MARK-3[®]

185cc Composite Fan & Ignition System Spare Parts

Overview:

701110 (NEW)

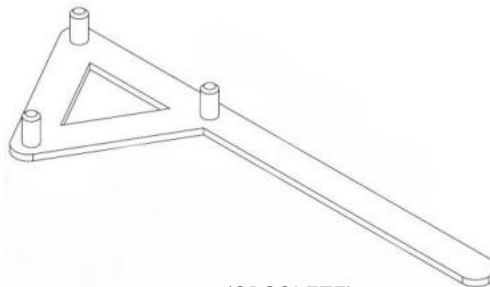
The R-603 aluminum cooling fan (800113) has been replaced by the R-603N composite polymer fan (701110):

- Material is glass fiber reinforced nylon;
- The new fan is approximately 0.3 lb lighter (46% weight reduction);
- The composite fan is a direct replacement to the aluminum fan.

For mounting the new fan, use Lockwasher M5 Teeth Serrated (801163) instead of R-791 Split Lockwasher (800489) to provide a better grip on the composite.
